BANK PROTECTION AND RIVER TRAINING  
(AFPM) PILOT PROJECT  
FAP 21/22

COMMENTS TO INTERIM REPORT  
AND ANSWERS

OCTOBER 5, 1992

Subject: **Comments to Interim Report**

32. Volume 1, Page 3-31, Figure 3.6-1

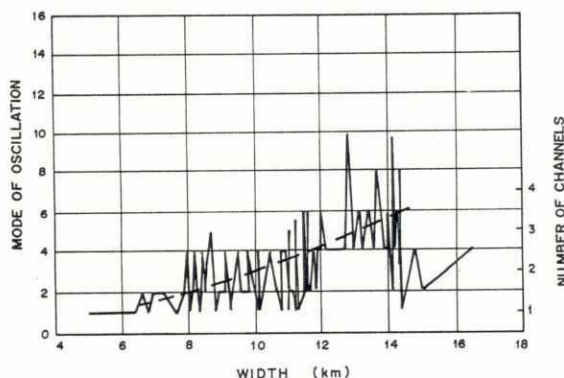
*How is it possible to have less than one channel ?*

Figure 3.6-1 indeed needs revision as far as the axis on the right side is concerned. A revised figure is given below.

Correct Figure 3.6-1
